AGENDA
CITY OF HALF MOON BAY
ARCHITECTURAL ADVISORY COMMITTEE (AAC) MEETING

- IV. COMMITTEE MEETING ITEMS**
 - a. PROJECT:.** New Single Family Residence Resubmittal
CITY FILE #: PDP-20-069
LOCATION: 574 Magnolia Street
OWNER/APPLICANT: Hailekiros & Simin Hailu

Date: July 15, 2021
To: Architectural Advisory Committee Members
From: Brittney Cozzolino, Associate Planner
Subject: 574 Magnolia Street, New Single-Family Residence, PDP-20-069

CONNECT 6T+CG: HAILU RESIDENCE
574 MAGNOLIA ST, HALF MOON BAY, COUNTY OF SAN MATEO, CA 94019
PARCEL #: 064-342-230

SHEET TITLE
CONNECT-HOMES
SAMPLE PROJECTS

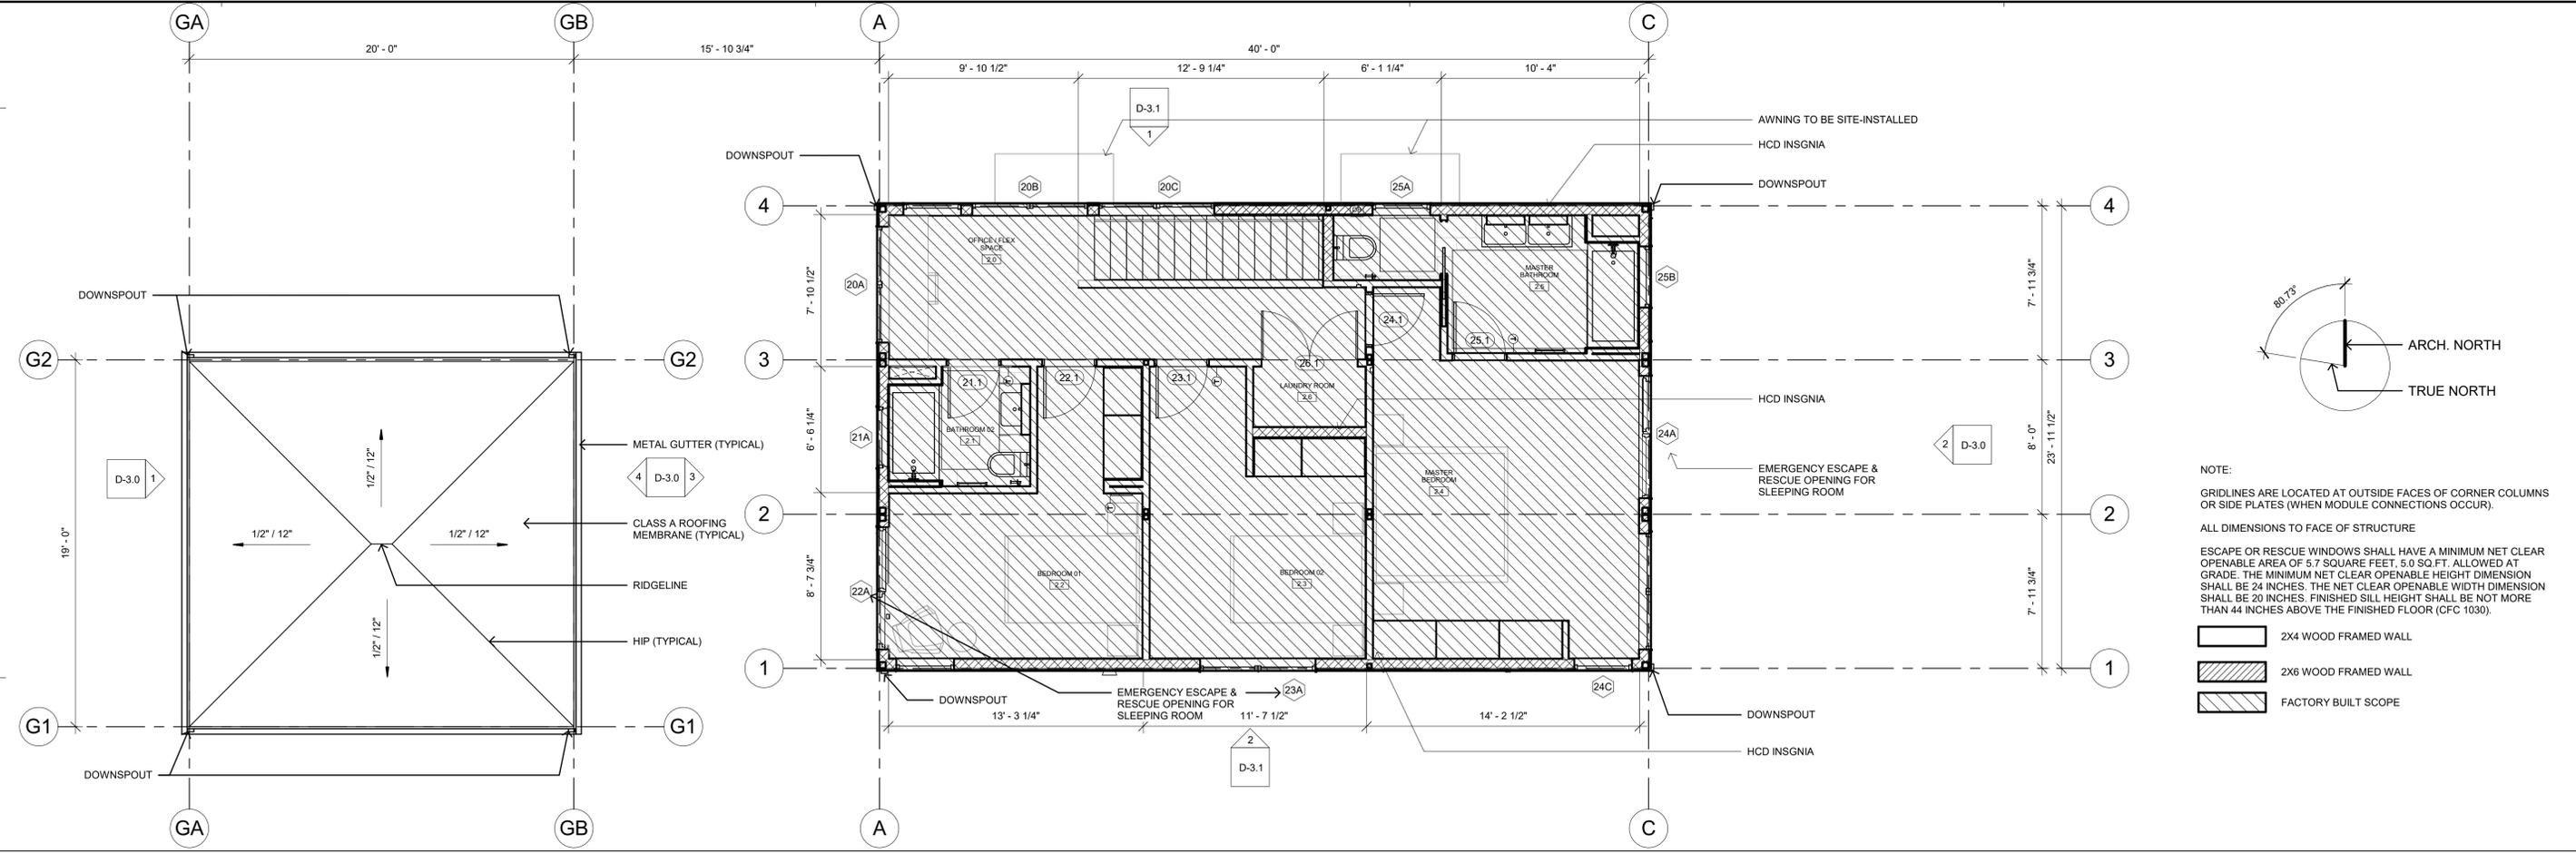
The applicant shared images of the modular home details for "Connect Homes" which has a contemporary aesthetic.

The AAC responded that that this approach is encouraging but that articulation, overhangs, and numerous other details need to be included. In consideration of this additional information, the AAC confirmed that a contemporary approach is preferred and that a flat roof would therefore be acceptable provided that site planning and architectural details can be addressed.
